**Expert Report on the Sio Silica Proposed  
Vivian Silica Sand Project**

The Rural Municipality of Springfield, Manitoba

Christopher J. Neville, M.Sc., P.Eng.

January 12, 2023

Figure 1. Concept for the proposed well layout during operations

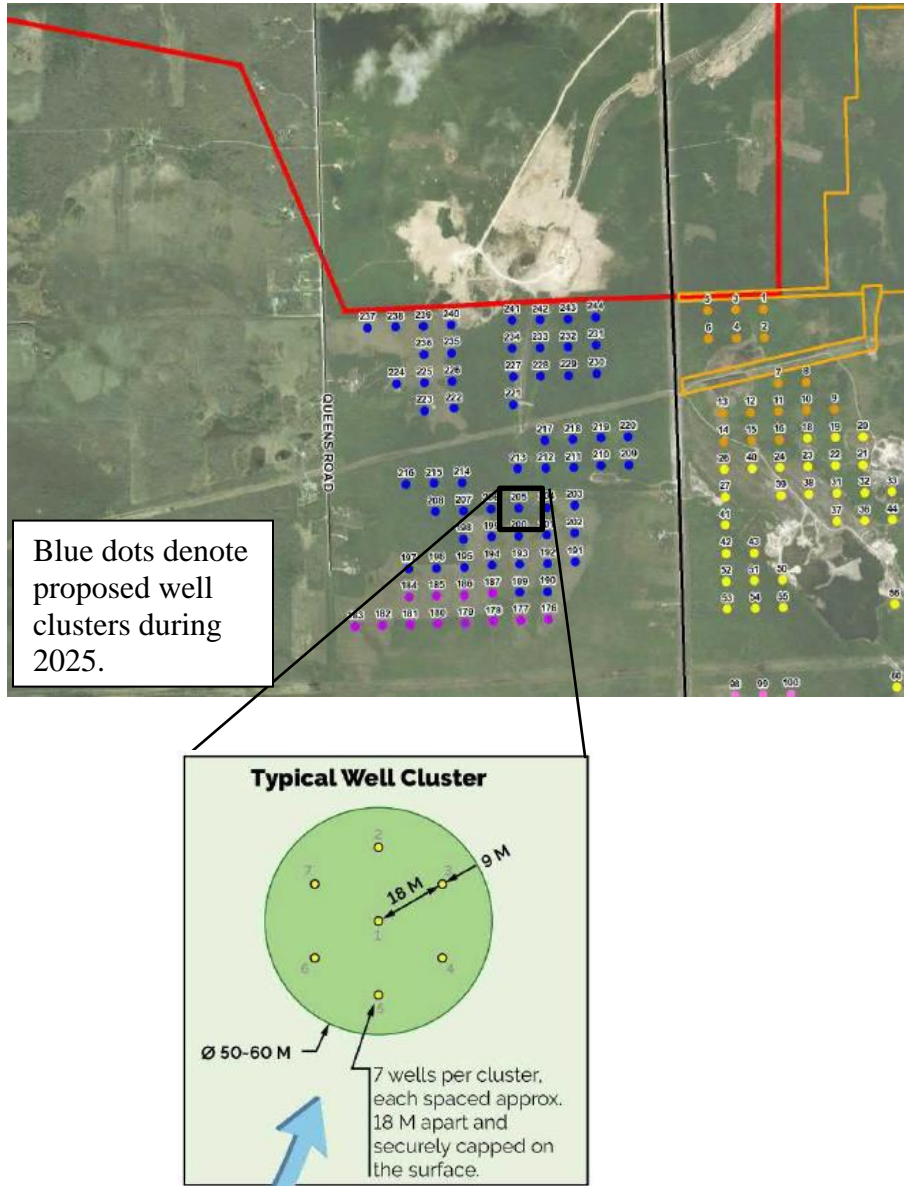
2. A mining plan for the first five years of operations is presented in Figure 6-5 of the *Hydrogeology and Geochemistry Assessment Report*. Referring to the excerpt from this figure shown here in Figure 1, each blue dot represents a cluster of 7 wells that will be drilled, operated and abandoned during 2025. The corresponding schedule of pumping is shown in Figure 6-7 of the report. During each year, pumping will shift from one cluster to the next (for example, from Cluster 213 to Cluster 214).

In response to RMSF-IR-004, the proponent clarified the pumping rates assumed in the impact assessment. Each well in the cluster is planned to be operated for approximately 4 days at a variable rate ranging from 262 m<sup>3</sup>/day to 654 m<sup>3</sup>/day (48 to 120 USgpm). If all 7 wells in a cluster were operating continuously this would correspond to 1,834 m<sup>3</sup>/day to 4,578 m<sup>3</sup>/day (336 to 840 USgpm). It is indicated in the response that the overall average combined production rate is expected to be 2,943 m<sup>3</sup>/day. For the predictive simulations, during each year's simulated operating period the cumulative pumping is assumed to be 2,998 m<sup>3</sup>/day (540 USgpm), slightly higher than the expected average. The cumulative pumping of 2,998 m<sup>3</sup>/day corresponds to 550 USgpm, which is the rate assumed in the impact assessment, as indicated in Figure 6-7 of the *Hydrogeology and Geochemistry Assessment Report*.

3. The responses to RMSF-IR-005 clarify that there may be extraction pumping at the same time as treated pumped water is re-injected at wells in the same cluster. The *net* groundwater withdrawals may therefore vary from 100% to some smaller fraction of the 550 USgpm, depending on the rate at which water is re-injected.
4. It is indicated on Page 22 of the *Hydrogeology and Geochemistry Assessment Report* that extraction wells within each cluster will be located “approximately 22 m apart”. This is not consistent with the conceptual layout shown in Figure 2-B (see Figure 1 below), which suggests that the wells will be spaced 18 m apart. In response to RMSF-IR-006, the proponent has indicated that the text in Section 2.3 and Figure 2-B of the *Hydrogeology and Geochemistry Assessment Report* should have reflected a well spacing of 18 m.

The proponent has also indicated in the response to RMSF-IR-006 that “new efficiencies have been realized” that may allow for an increase in the distance between wells to produce the same amount of sand. It is my understanding that these efficiencies are inferred from updated geotechnical analyses, but they may also have been inferred from pilot testing referred to the response to RMSF-IR-005. The critical factor controlling the spacing between wells will be the stability of the rock that overlies the Winnipeg Sandstone. This implies that the geotechnical investigations and analyses will have a critical bearing on the final design of the project.

**Figure 2. Map of existing groundwater users, colour-coded by aquifer**  
(Excerpt from AECOM, 2021b, Figure 1-3)

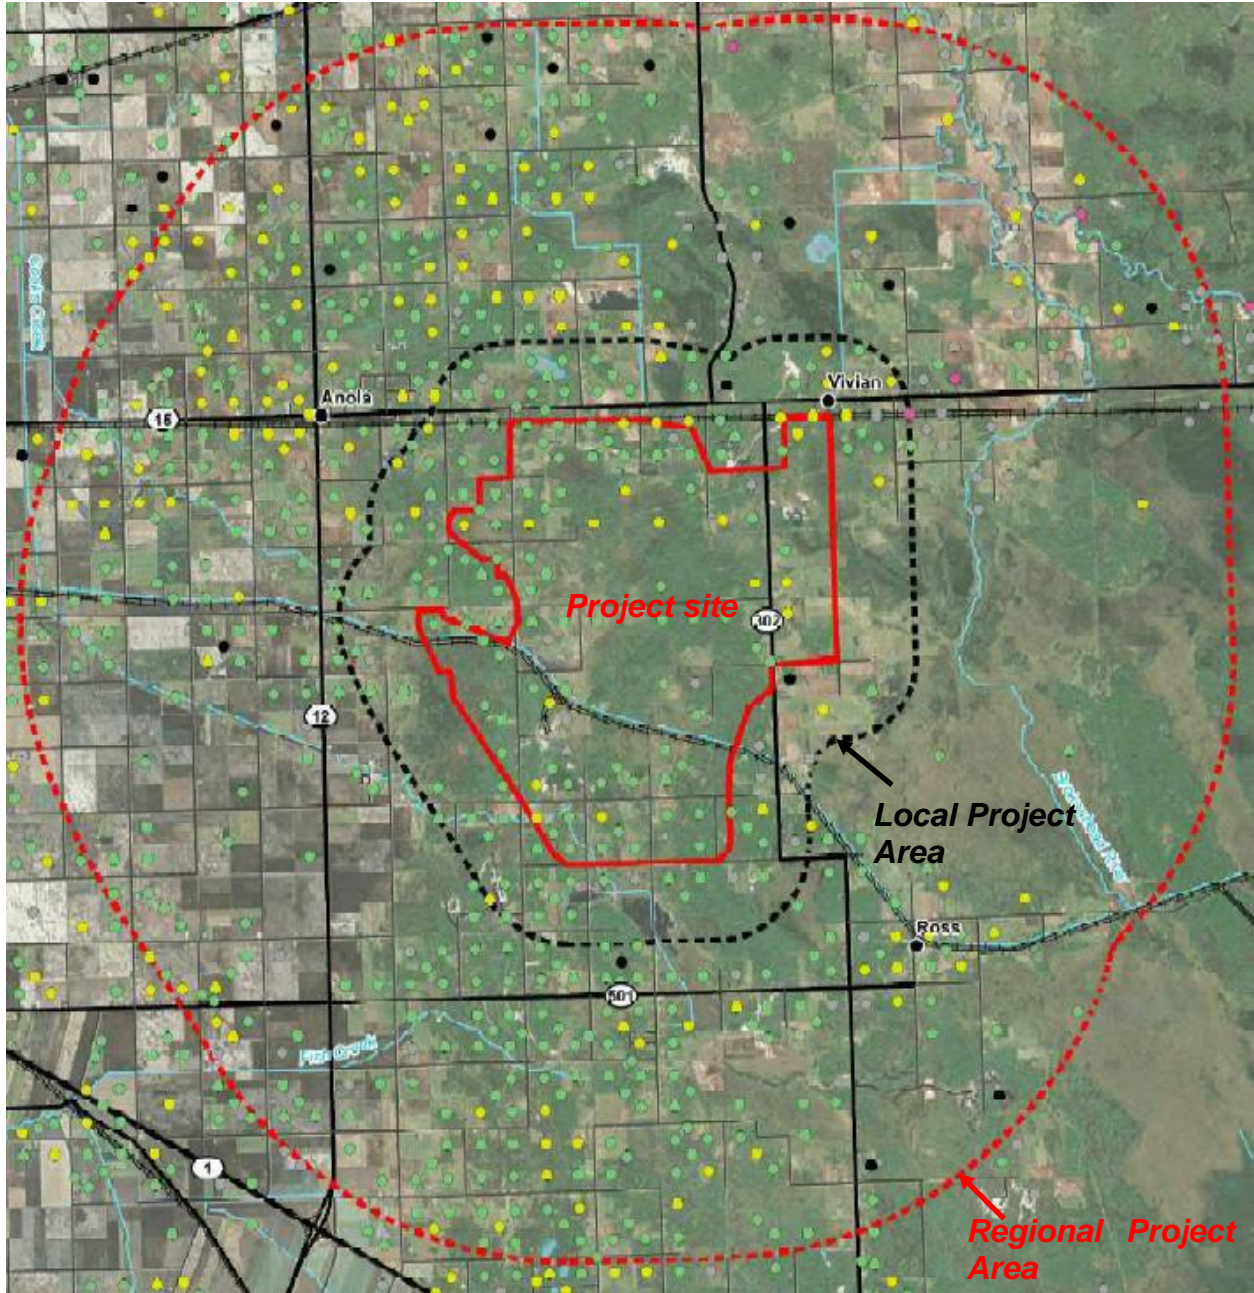
7. As part of the site investigation, a constant-rate pumping test was conducted at well Bru 95-7, which is open across the Winnipeg Sandstone. As shown in Figure 1-4 and Figure 3-1 of the *Hydrogeology and Geochemistry Assessment Report* and here in Figure 2, a relatively large number of domestic wells in the vicinity of Bru 95-7 were identified from the Manitoba provincial database. In the response to RMSF-IR-011 it is confirmed that only three of these wells were monitored during the pumping test, Obs 23901, Obs 66124 and Obs S1. Obs 23901 and Obs 66124 are open across the Red River Carbonate Formation and are located 660 m and 491 m from the pumping well, respectively.

Only Obs S1 is open across the same formation as the pumping well and it is located 960 m from the pumping well. It is indicated in the response to RMSF-IR-011 that well Obs S1 is a geoexchange well. The yellow dots in Figure 2 denote the locations of wells indicated the water well database as being open across the Winnipeg Sandstone. It is not indicated in the report whether Obs S1 was the nearest accessible domestic well in the Winnipeg Sandstone.

**Figure 3. Distance-drawdown analysis for Bru 95-7 pumping test**  
Adapted from AECOM (2021; Appendix E.2)

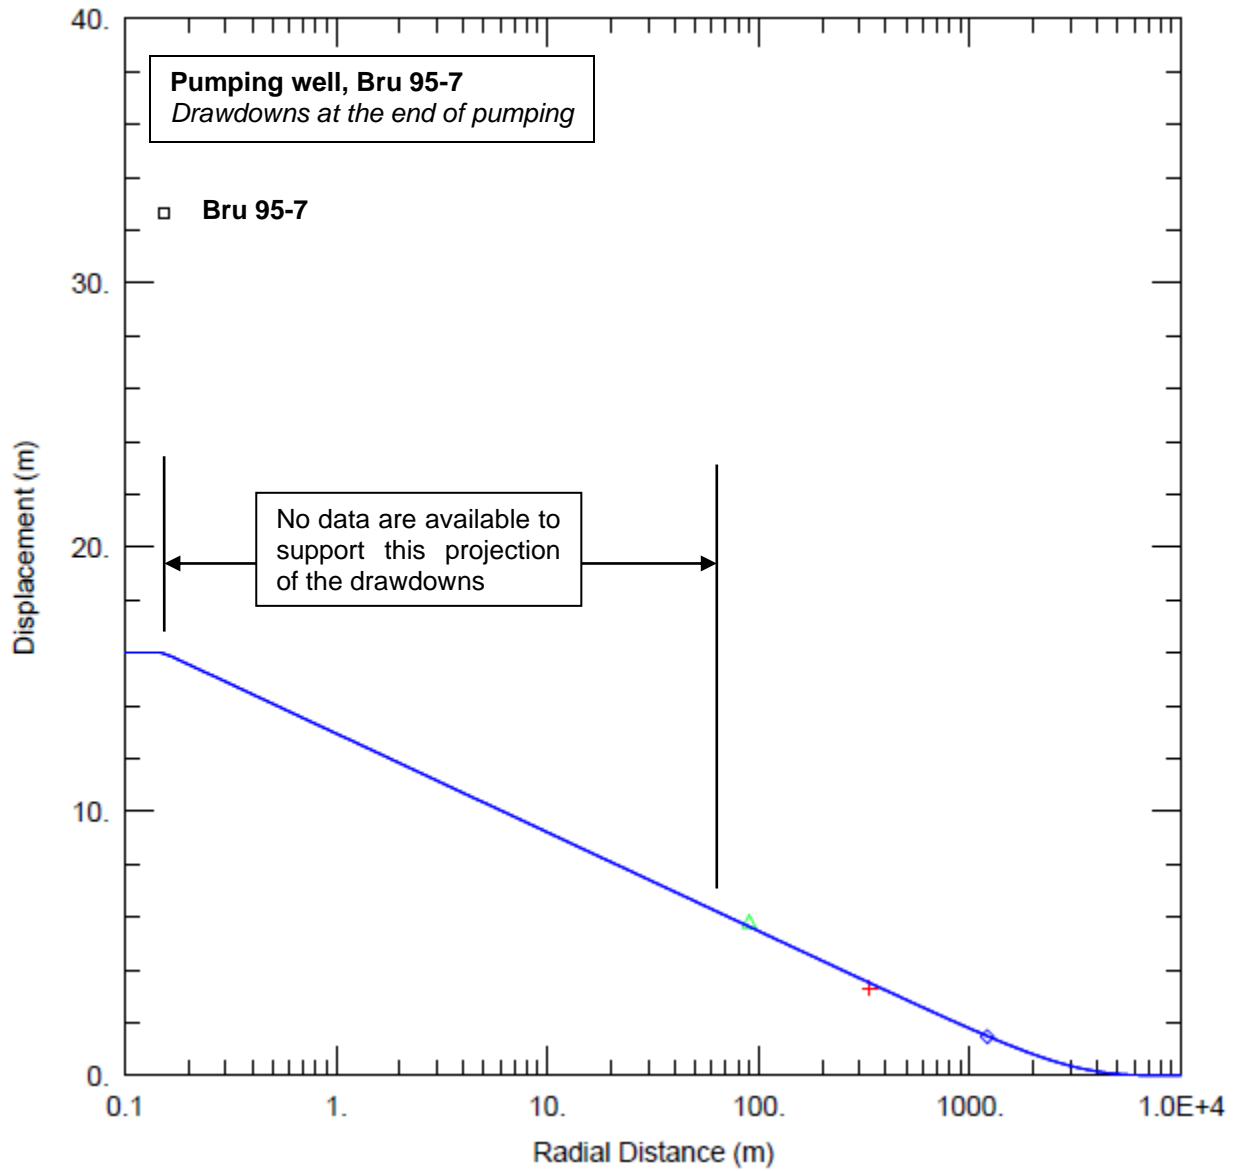
8. Although it is indicated on Page 29 of the *Hydrogeology and Geochemistry Assessment Report* that a step test was conducted at the pumping well Bru 95-7 prior to the constant-rate pumping test, no data or analyses are reported. It is indicated that “Evaluating the hydraulic efficiency of the pumping well was not part of the scope of work.” It is unfortunate that the data from the step test were not analyzed. In my experience, distance-drawdown analyses provide the most reliable estimates of the bulk-average transmissivity. As shown in the distance-drawdown plot reproduced from Appendix E shown here in Figure 3, the data from only three observation wells were considered in the proponent’s estimation of the representative bulk-average transmissivity of the Winnipeg Sandstone. This is important here because the transmissivity of the Winnipeg Sandstone is the key parameter for the prediction of the propagation of the effects of pumping.

9. The data from step drawdown tests can frequently be used to identify additional well losses so that the drawdowns from the pumping well can be treated as if the well was another observation well. The data from the step test may have provided valuable insights explaining the relatively low efficiency of the pumping well (the observed drawdown at the end of pumping of about 32.5 m is about double that inferred from the distance-drawdown analysis).

It is suggested on Page 31 of the *Hydrogeology and Geochemistry Assessment Report* that the “excess drawdown” in the pumping well was due primarily to residual drilling mud in the sand pack and surrounding formation. This does not appear to be consistent with the text on Page 26 of the report, which indicates that an extensive development effort was undertaken prior to conducting the constant-rate pumping test.

**Figure 4 Inference of additional well losses in Bru 95-7**  
Adapted from AECOM (2021; Appendix E.2)

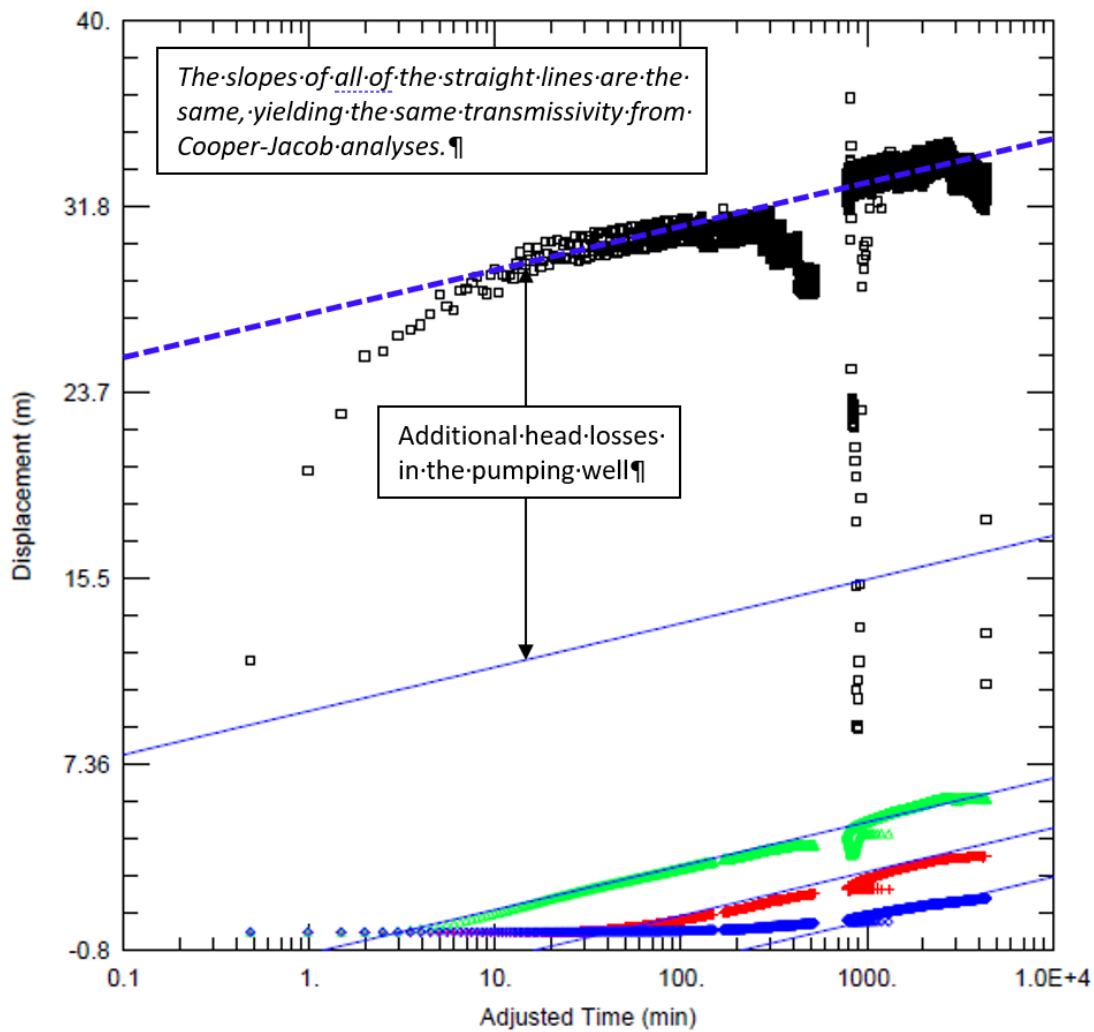
10. The analytical models used to match the observations from the Bru 95-7 pumping test are based on the Theis (1935) model of an ideal confined aquifer. Among the most important assumptions of the Theis solution is that the aquifer is homogeneous. Some of the results of the analyses listed on Table 3-C of the *Hydrogeology and Geochemistry Assessment Report* are consistent with this assumption, while others are not. The transmissivities estimated from matching the observation well drawdowns with the Theis solution and the Cooper and Jacob (1946) straight-line analysis are consistent, as they should be when applied in a consistent manner. In contrast, the matching of the pumping well drawdowns with the Theis solution yields a transmissivity that is about half of the value estimated for the observation wells. The transmissivity estimated by matching the observed pumping well drawdowns with the Theis (1935) solution is not reliable here, as the analysis is affected by additional well losses. As shown in Figure 4 here, the Cooper-Jacob analysis effectively filters the additional well losses and the transmissivity estimated for the pumping well is consistent with the observation wells.

**Figure 5. Recovery analysis for the Bru 95-7 pumping test**  
Adapted from AECOM (2021; Appendix E.2)

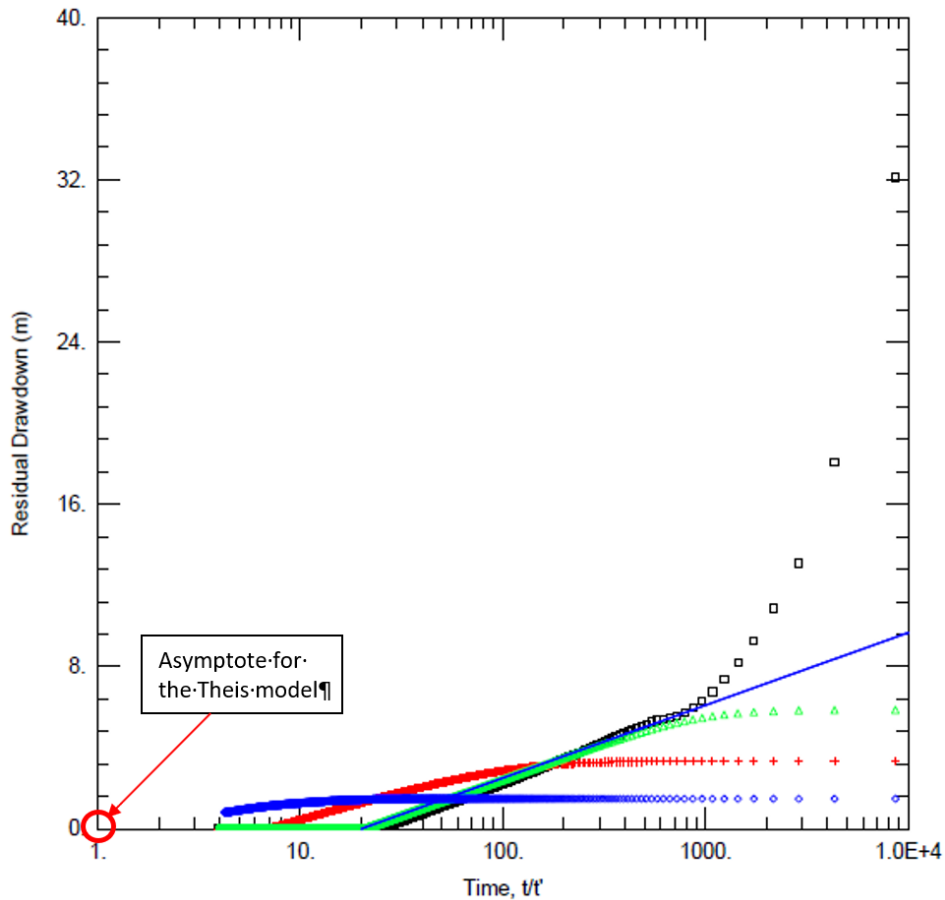
11. The responses observed following the end of pumping are complex. In an ideal confined aquifer, the recovery data for the pumping well and observation wells should eventually approximate a single straight line that approaches the asymptotic value of zero residual drawdown as  $t/t'$  approaches a value of 1.0 (indicated by the red circle in Figure 5). The data satisfy neither of these conditions. The fact that the recovery records approach values of zero drawdown for values of  $t/t'$  of about 9, 20 and 25 rather than 1.0 suggests that the drawdown cone at the end of pumping is replenished by a source of water in addition to confined storage.
